**THE CITY OF CANADA
BAY SUBMISSION
APPLICATION NO. SS1 6307**

**M4 East WestConnex
Tunnel Project**

JOB NO. 15275
26 October 2015

FIGURE 10: Location of noise walls near Concord Road Interchange

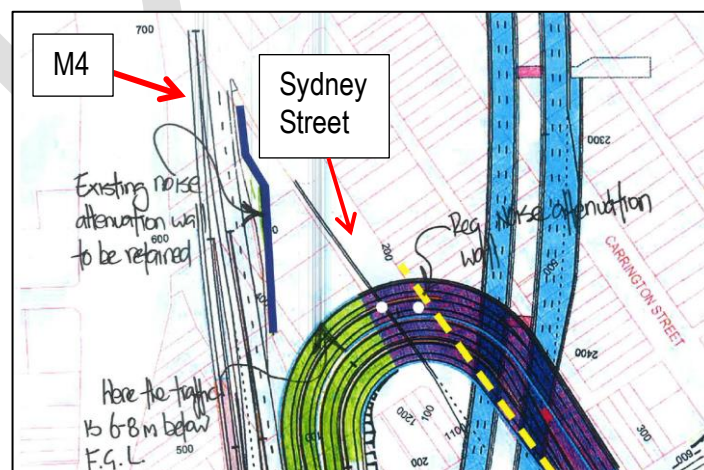
The road widening and land resumptions will expose some residents near the Concord Road Interchange to road noise, where previously there had been limited exposure. Residents have concerns regarding increased road noise from general traffic and compression braking.

1. Noise walls can reduce the impacts of road noise including tyre noise and compression braking. The residents of Carrington St have requested a sound wall along the south-eastern edge of the dive structure which Council deems reasonable (see Figure 10).
2. Additionally Council requests the south-eastern edge of the dive structure be mounded and planted to further reduce noise impacts and improve visual amenity.
3. Consideration may be given to low noise road surfaces in the area near dwellings and signage to remind truck drivers to avoid compression braking.

FIGURE 11: Proposed facilities layout of Cintra Park, post-construction

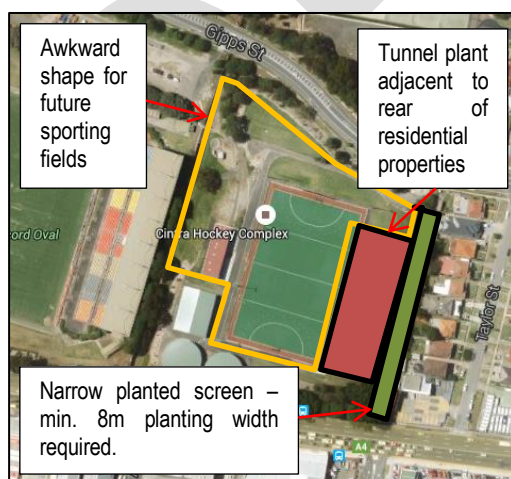
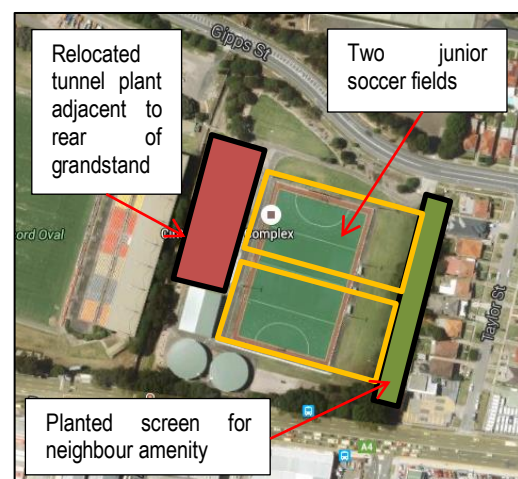
Council is of the understanding that the Cintra Park playing fields which have been resumed as part of the tunnel project will be eventually returned to Council. The EIS shows tunnel plant on the eastern side of Cintra Park adjacent to residential dwellings. The tunnel plant has the potential to cause loss of amenity to residents: potential noise amenity and visual amenity, since it backs onto residential dwellings (see Figure 11).

Council seeks clarification regarding the location of the facilities proposed.

Council requests consideration be given to relocating tunnel plant adjacent to existing Council plant on the western side of Cintra Park, adjacent to the Concord Oval Eastern grandstand (see Figure 12). This would remove any amenity issues for residents. Relocating tunnel plant to the western side of Cintra Park would provide suitable area for two junior soccer fields on the site, which is a more efficient use. Council anticipates a densely planted screen of minimum 8 metres width would be required along the boundary with residents.

FIGURE 13: Proposed Relocated Bus Stops on Concord Road

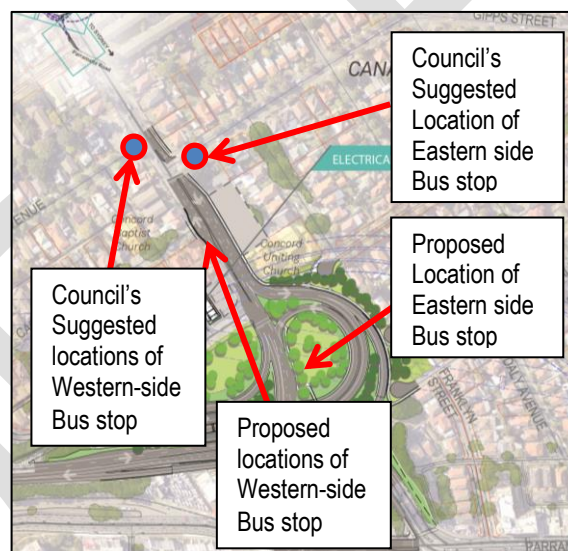
No details regarding relocation three bus stops on Concord Road and it appears two bus stops on the east side of Concord Road will be consolidated into one.

A bus stop looks to be relocated to the intersection of Carrington Street. It appears the current left turn only onto Concord Road will be closed. Council does not support this closure. It would limit the opportunity for long vehicles to manoeuvre and/or perform a U-turn within Carrington Street (see Figure 13).

The length of the proposed bus pull in area appears to be insufficient to accommodate a bendy-bus and the required draw-in and a draw-out length, which means bendy-buses, would block traffic on Concord Road when stopped.

Council seeks clarification on how bendy-buses will be accommodated at the western side bus stop.

In consideration of the concerns regarding pedestrian access to this location and the absence of a notable origin/destination at the proposed location, both the eastern side bus stops could be relocated to just north of Patterson Street.

It is recommended that the western side bus stop should have sufficient pull in length to accommodate a bendy-bus.

FIGURE 14: Potential linkage of Proposed Cul-de-sacs

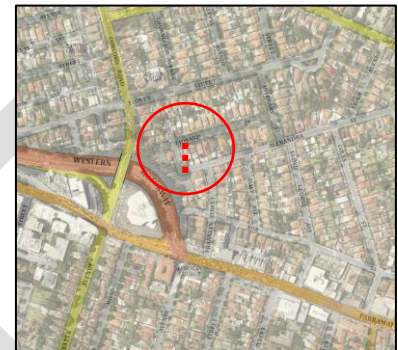
The reduced linkages require U-turns and these can be particularly difficult for garbage trucks/large vehicles. Additionally, there is an increased risk of anti-social behaviour in cul-de-sacs (see Figure 14).

Linking Alexandra Street with Edward Street, similar to existing would be preferred. Linking roadways would also provide improved passive surveillance, and reduce the risk of antisocial behaviour.

FIGURE 17 - Existing Cycle Routes in Vicinity Affected by WestConnex Work Sites

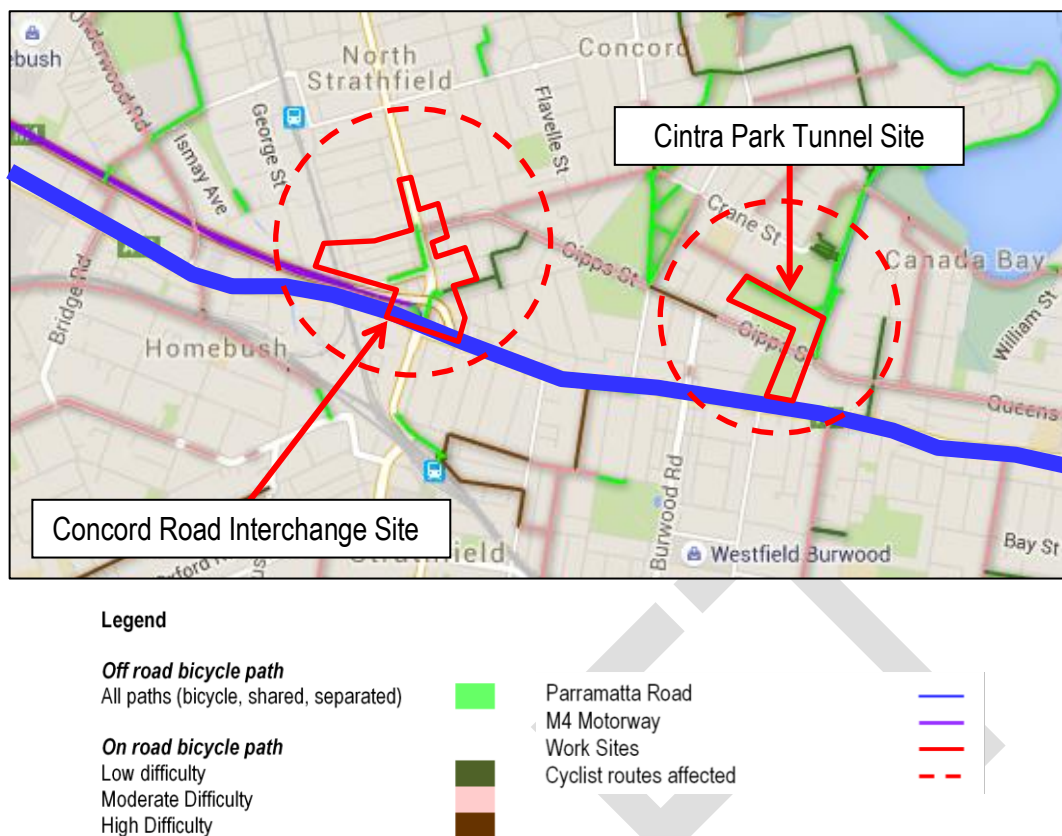
Council is concerned that the proposed cycleway diversion route provided in the EIS in Figure 6.19 is insufficient and not functional for long term use. Figure 17 on the following page shows the various types of cycle ways in the vicinity and areas where the work sites affect existing cycle paths.

It is important for commuter and recreational cyclists that safe access alternatives are provided around the construction sites. Council requests a revision of the proposed cycleway diversion route for this area. Consideration should be given to clearly marked routes which separate cyclists from Construction Traffic, for the duration of the works. Appropriate and safe cycle paths are required, post construction.

FIGURE 18: Open Space within Concord Road Interchange

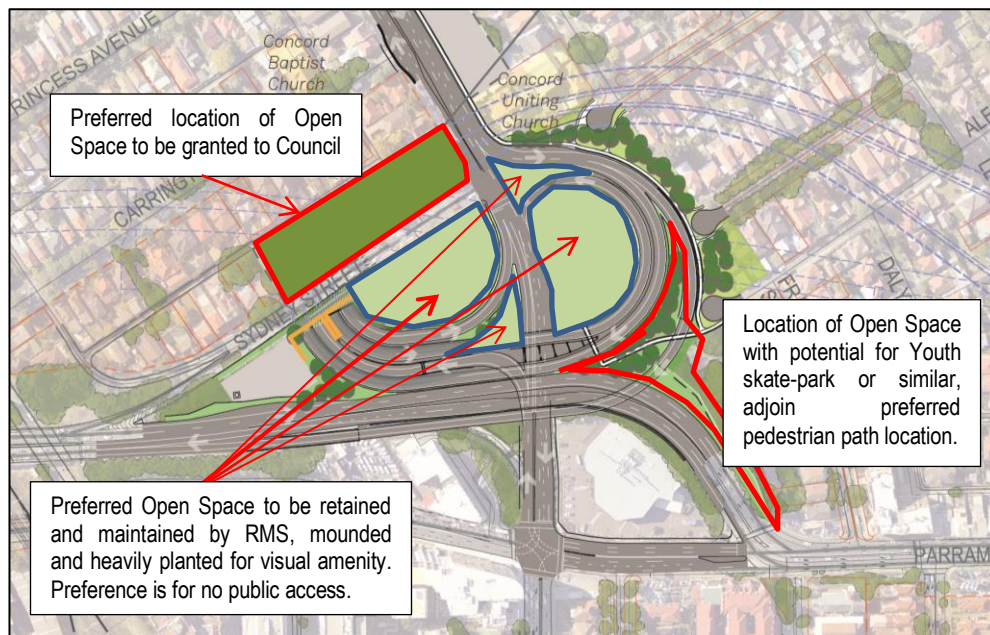
The Concord Road interchange shows four areas of potential open space. These areas would require pedestrian access across busy roads and do not have parking or facilities. Due to the lack of connectivity and parking, Council would prefer the centre area of the Concord Road Interchange not be public accessible (see Figure 18 on the following page).

Council suggests instead the area become greenspace which is mounded and densely planted with canopy, screening and understorey planting. As low maintenance areas, it would be managed and maintained by RMS. The greenspace would provide visual amenity to motorists and nearby residents.

Council would prefer instead as open space, the area over the roof of the dive structure for passive use. As noted elsewhere, Council would request noise-walling, mounding and planting along the south-eastern edge along Sydney Street.

FIGURE 19: Proposed Pedestrian Access on Western Side on Concord Road

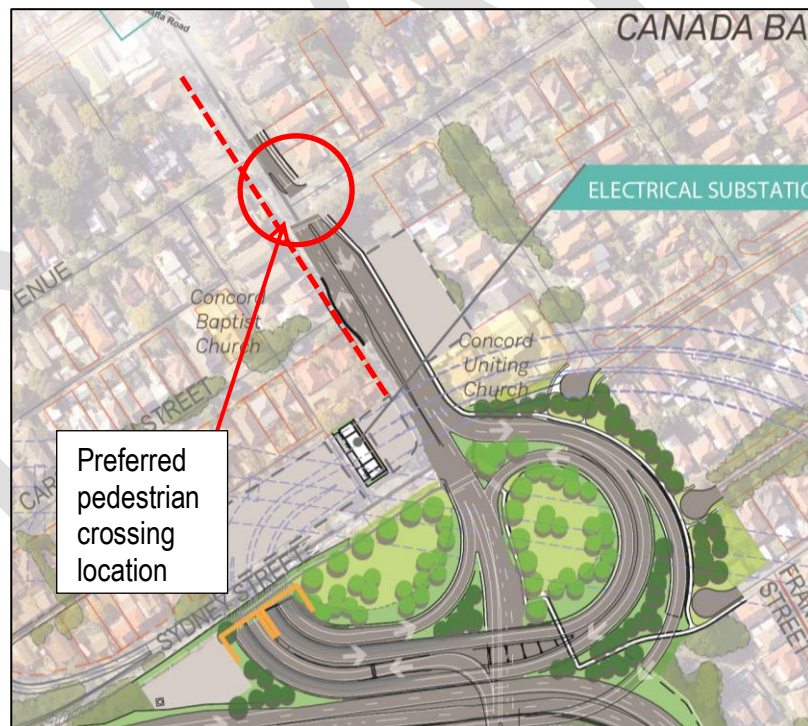
The access provisions for pedestrians along the west side of Concord Road appear to be reduced by the project (see Figure 19).

Consideration be given to maintaining pedestrian access along the western side of Concord Road to as far south as Sydney Street. Pedestrians who wish to reach Parramatta Road would need to cross safely at the proposed Patterson Street intersection.

FIGURE 20: Proposed Residential Access Route For Concord Road South Bound

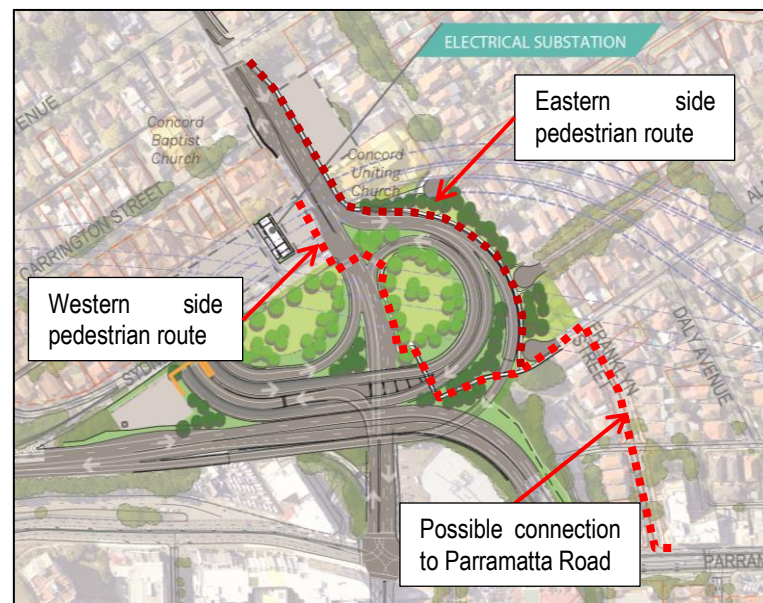
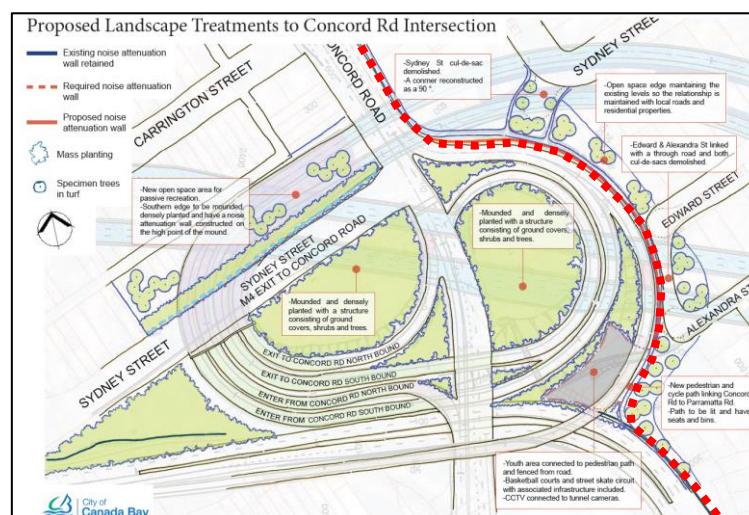
The at-grade pedestrian crossing where westbound traffic on WestConnex merges to Concord Road southbound is considered very dangerous for pedestrians (see Figure 20). Council does not support a crossing due to vehicles speed and the grade/curvature of the roadway. Council instead supports continuation of the proposed footpath which runs along the east side of Concord Road and around perimeter of the on-ramps.

Council recommends that pedestrian access not be provided through the Concord Road Interchange. The proposed route is generally unattractive for pedestrians, requiring multiple road crossings. Council considers the pedestrian bridge from northern side of existing M5 to the eastern most central open space area to be counter-intuitive to pedestrian movement through the area.

Council suggests the proposed bridge be eliminated and the pedestrian path on the eastern side be continued further south, to link the end of Alexandra Street to the end of Ada Street and to the Parramatta Road / M4 intersection to meet with Parramatta Rd (see Figure 21 on the following page). Council considers the traffic signals at Mosely St would provide a better pedestrian experience down to the station than amongst all the proposed roads.

FIGURE 22: Council Heritage Map near Concord Road Interchange

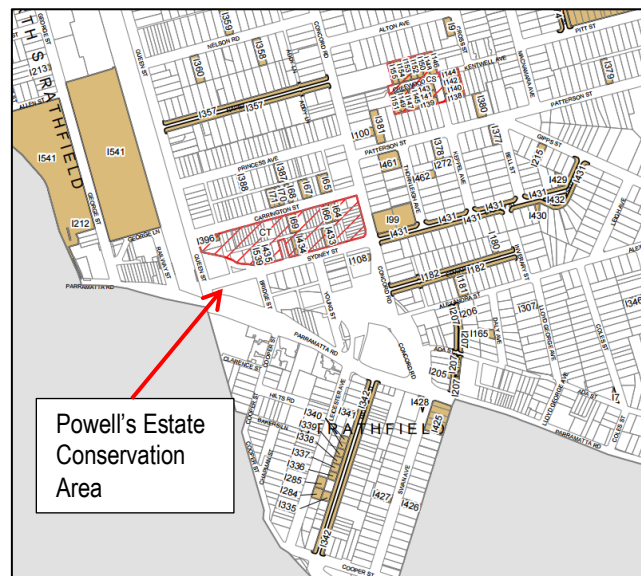
The Powell's Estate Conservation Area, and in particular, heritage items identified in Council's LEP, (see Figures 22 and 23 on the following page) needs to be photographed and recorded prior to demolition. This includes taking photographs of the interior, exterior and grounds of the heritage items. WestConnex is requested to provide hard and electronic copies to Canada Bay Council and Canada Bay Local History Library.

FIGURE 23: Council Heritage Map near Cintra Park Tunnel Site

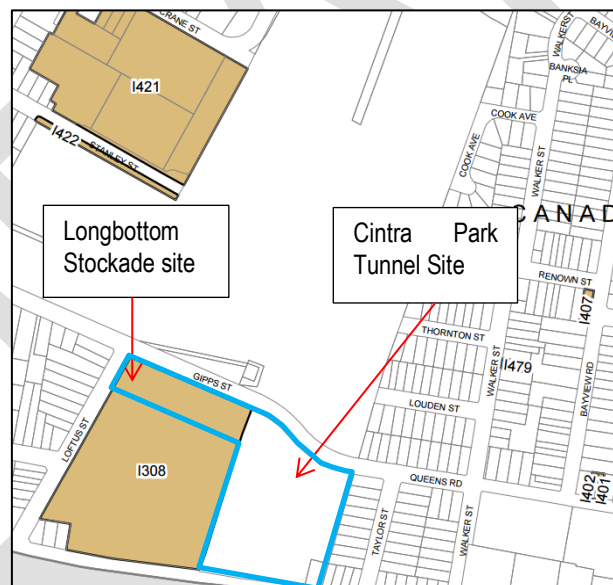
In terms of environmental heritage, it is essential the trees in Concord Oval (Heritage Item I308) be protected from damage during construction works. In all aspects of heritage conservation and demolition Council should be invited to provide input into the identification of opportunities to enhance conservation options of archaeological and heritage sites.

FIGURE 25: Potential Youth Facilities' Location

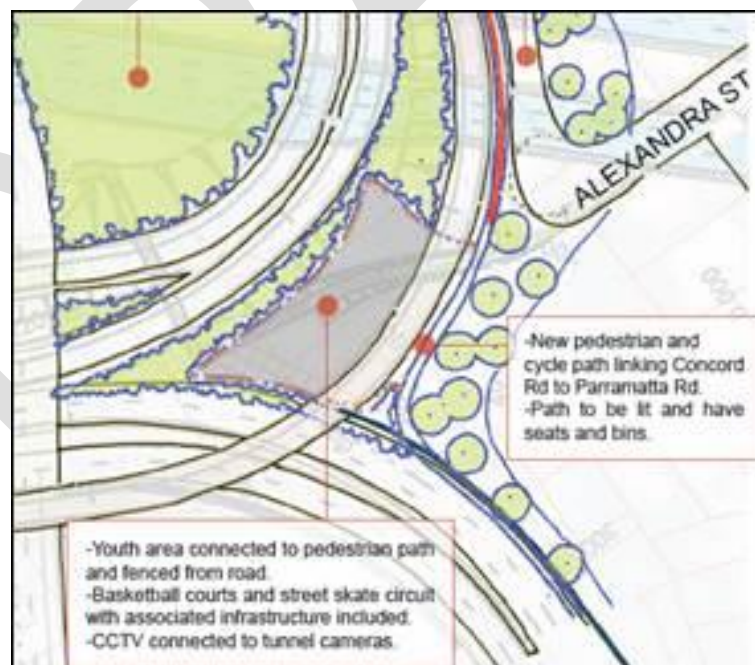
The proposed path linking Concord Rd, Sydney Rd, Edward St, Alexandra St and Parramatta Rd will require street-lighting and street furniture, and (see Figure 25). If sufficient space is available, the area under the ramp heading towards Parramatta could be programmed for youth use. Council suggestions include a basketball court or street skate area.
